HORSHAM DISTRICT COUNCIL CONSULTATION

TO:	Horsham District Council – Planning Dept
LOCATION:	Land North West of Southwater
DESCRIPTION:	Outline planning application, with all matters reserved (except for primary access to the highway) for a phased development comprising: the demolition of existing buildings and the construction of residential dwellings (including affordable housing) (Use Classes C2 and C3); a mixed-use neighbourhood centre (Use Classes E and F); education facilities (Use Class F1(a)); business and employment floorspace (Use Classes B2, B8 and E(g)); redevelopment of existing agricultural buildings including construction of a building for community use (Use Classes E and F2); improvements to public rights of way; sports pitches; gypsy and traveller pitches/plots; public open space; landscaping, and associated infrastructure.
REFERENCE:	DC/26/0366
RECOMMENDATION:	No Objection / More Information / Modification
SUMMARY OF COMMENTS & RECOMMENDATION: Please note the request for a number of minor amendments to the parameter plans, together with the provision of additional supporting information. In addition, please be advised that the LVIA remains under review at this ti

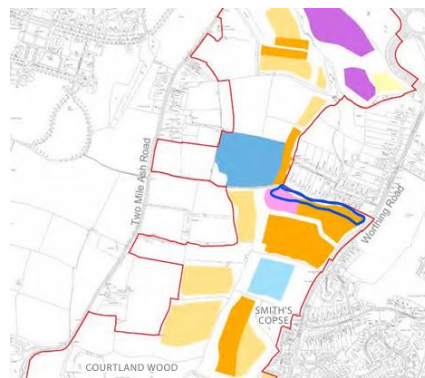
MAIN COMMENTS: Parameter Plans - Land Use Strategy 1. There is concern regarding the long term retention of the existing vegetation along the eastern boundary adjacent to properties on Wording Road. Additional information is required to understand the proposed relationship between the new dwellings and the existing tree belt, including any anticipated impacts on tree RPA's, future development pressure as

result of shade within the new gardens, and the perceived level of screening.

2. Unless demonstrated unnecessary, we request that the Parameter Plan be updated to secure a minimum 5m buffer between the existing dwellings and the proposed residential parcels.
3. Please remove 'surfacing' from the key and replace with 'Potential car park expansion land'. While it is acknowledged that it is unlikely the entire area would be surfaced due to existing constraints including TPOs, the current terminology implies that full surfacing is proposed. At this stage, no detailed design of supporting information has been provided for this area, and the key should therefore be amended to reflect the indicative nature of the proposal. In addition, it may be beneficial to provide a briefing note identifying the constraints such as existing trees and public footpath, etc.
